Reference: TENDER 30/2015 – Construction of Fishery Port (Port and Road Related Work) at

Duqm

Subject: Reply to Queries

CONSTRUCTION OF FISHERY PORT (MARINE & ROAD RELATED WORKS) AT DUQUM
SULTANATE OF OMAN
TENDER QUERIES CLARIFICATION

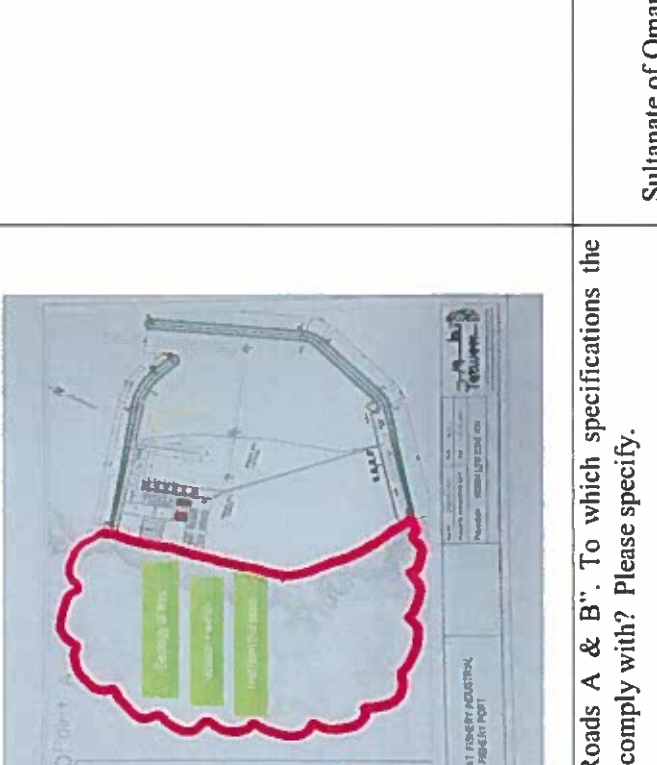
No	Item in Tender	Queries by Bidders	Response by SEZAD
91	Reports & Design References	<p>Kindly provide the geology strata 1KM from the seashore as shown in photo and can we use the clouded area for backfilling works?</p> 	<p>The requested information is not available.</p>
92	Design & Construction of Road	<p>Design for "Roads A & B". To which specifications the design should comply with? Please specify.</p>	<p>Sultanate of Oman, Highway Design Standards 2010</p>
93	Design & Construction Of Road	<p>The contractor shall be responsible to improve, divert, build and maintain the service "dirt road", from the present paved road (south of Park Inn Hotel Main Access Gate), up to the Point "A" (corner of the future Fishery Industrial Development Area).</p> <p>It is understood that a new permanent paved road shall be built in the near future, to serve the same scope. Could be</p>	<p>At present we do not have any plan/alignment for "dirt road" from (south of Park Inn Hotel Main Access Gate), up to the Point "A"</p>
